RE: Take 5 Oil Change 10415 Central Ave NE Grading and Drainage Plans Engineer's Stamp Date: 02/03/23 Hydrology File: L21D059B

RE: Take 5 Oil Change 10415 Central Ave NE Grading and Drainage Plans Engineer's Stamp Date: No Date Hydrology File: L21D059B

Following is a response to comments issued by your office on 1/30/2023. Grading Plan C-4.0 has been revised to address the comments and concerns.

C4.0

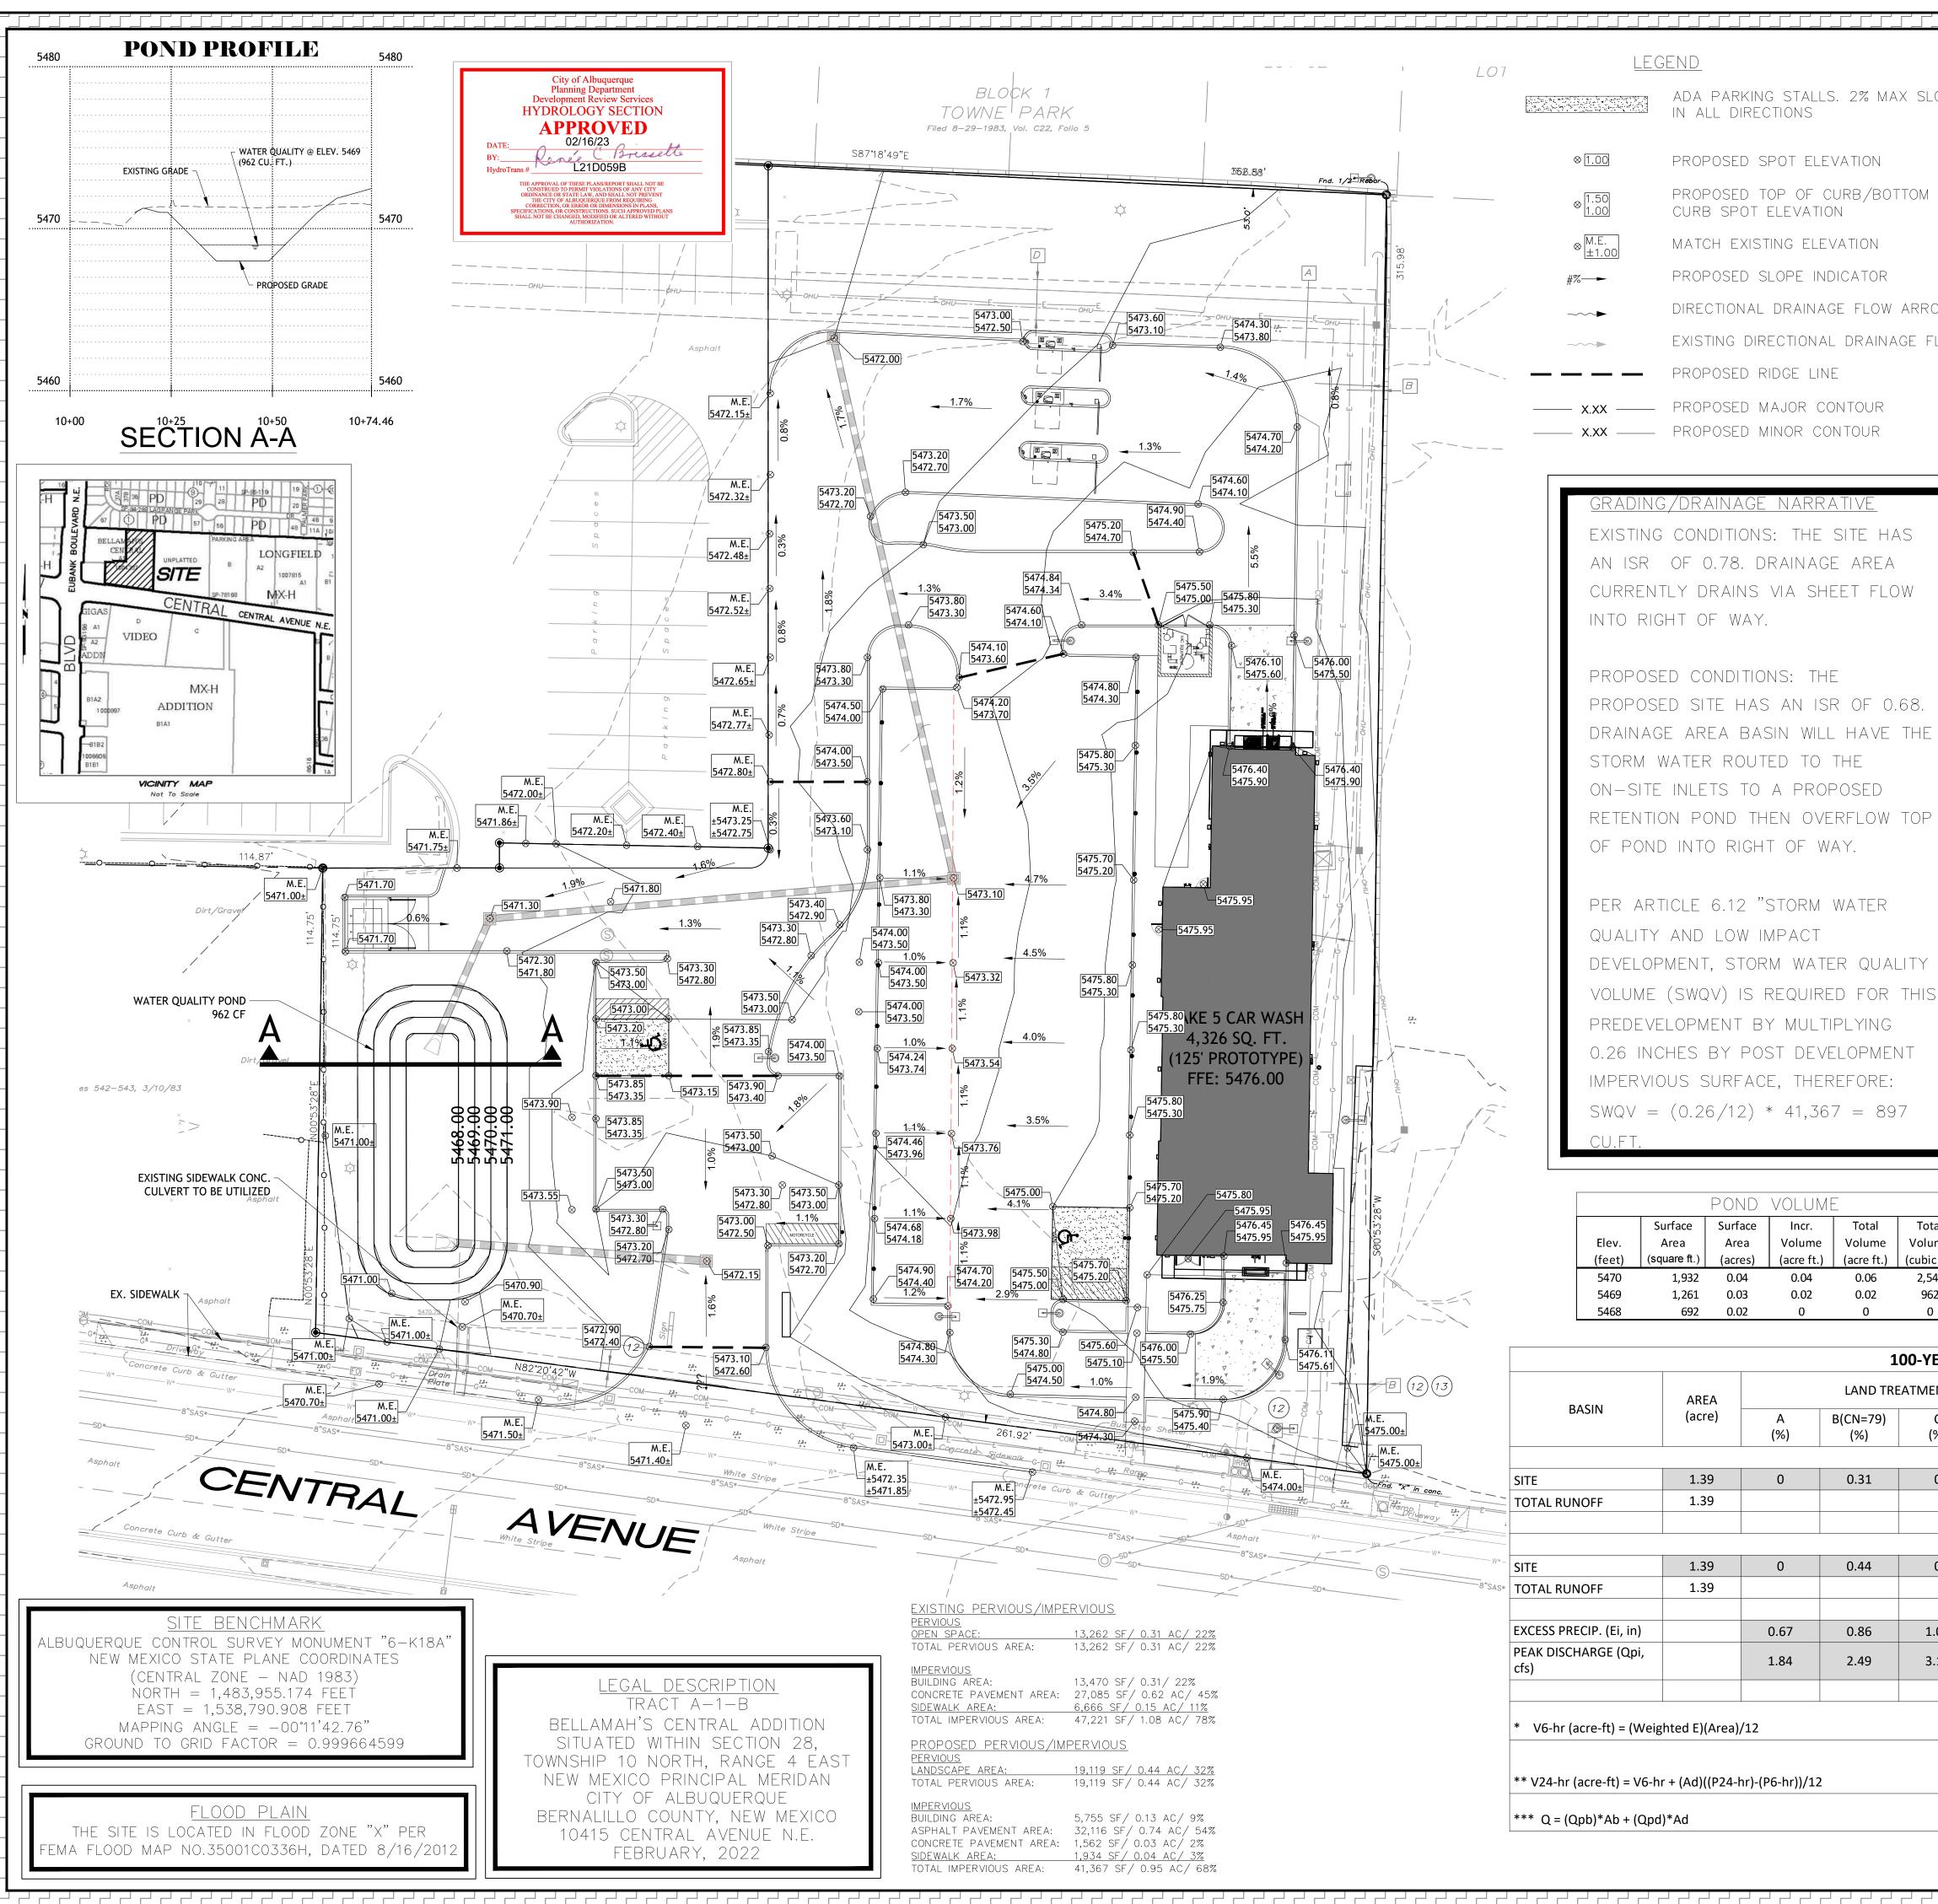
4. Please provide a cross section for the stormwater quality pond showing the top of pond, bottom of pond and the SWQ required volume elevation. Please add a note, "Side slopes need to be stabilized with Native Grass Seed (per City Spec 1012) with Aggregate Mulch or equal (Must satisfy the "Final Stabilization criteria" CGP 2.2.14.b.)".

5. Please add the volume provided under the Stormwater Quality Calculations.

9. Please use the procedure for 40 acre and smaller basins as outlined in Development Process Manual (DPM) Article 6-2(a). Please provide both the existing conditions and proposed conditions for the 100 year-6 hour storm event. These calculations should be on the Drainage Plan.

Response: A cross section is provided on the grading sheet C-4.0

Response: Calculation has been added to the grading sheet C-4.0

Response: Refer to calculation added on the grading plan sheet C-4.0.
